Intel[®] Atom[™] Processor E6xx Series

Specification Update

May 2013

Revision 016

Figure 10. 1U Natural Convection Heatsink Mechanical Drawing

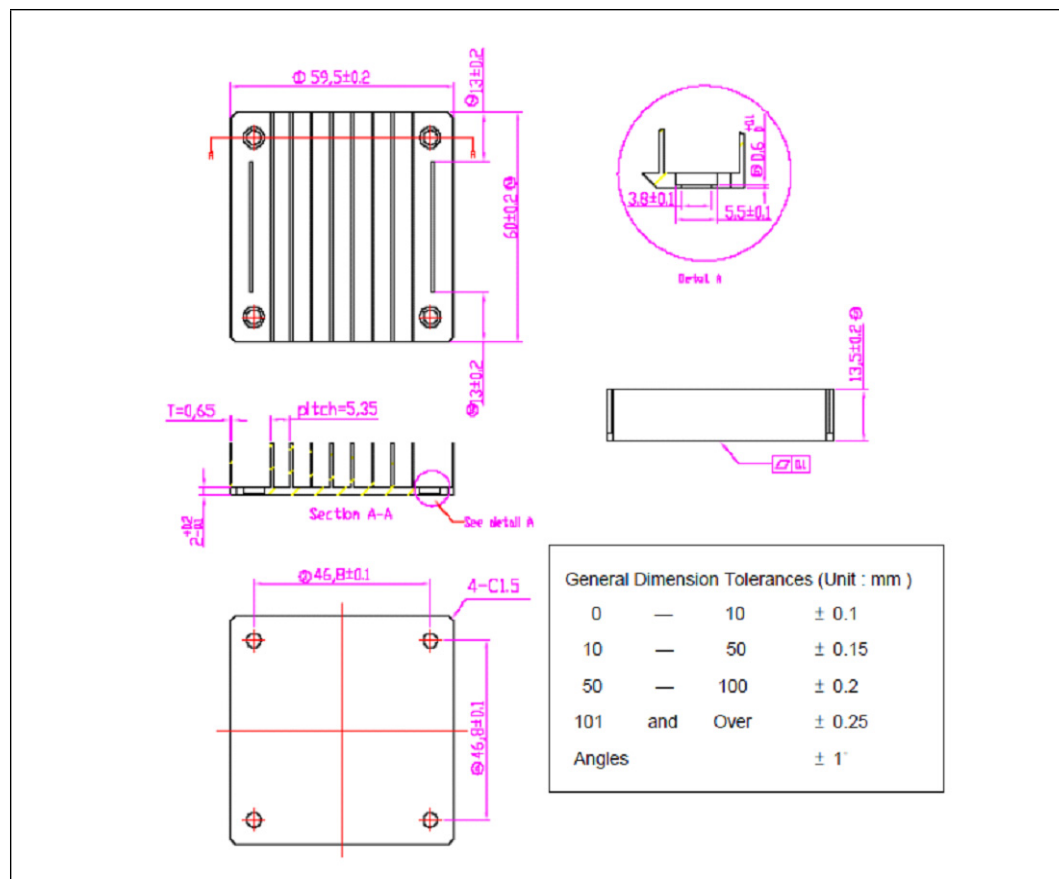
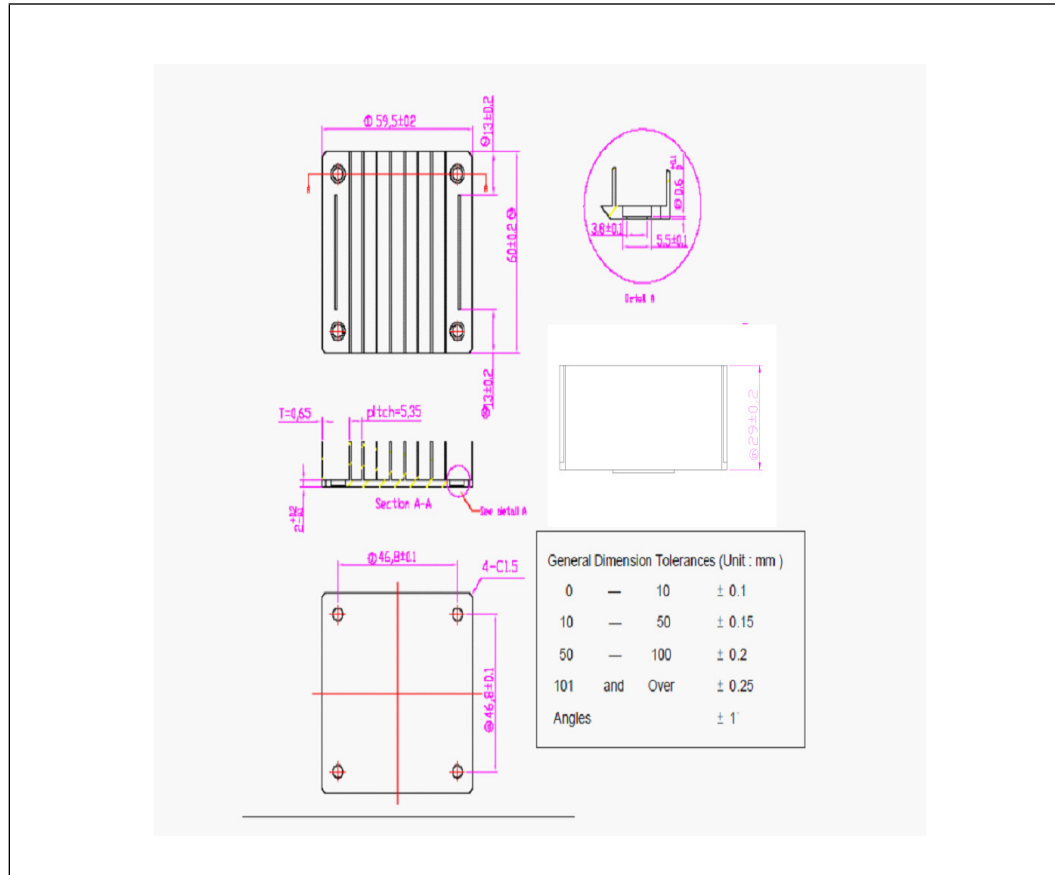
Issue: Heatsink height on Figure 10 "1U Natural Convection Heatsink Mechanical Drawing" has changed from 13.5 ± 0.2 mm to 29 ± 0.2 mm.
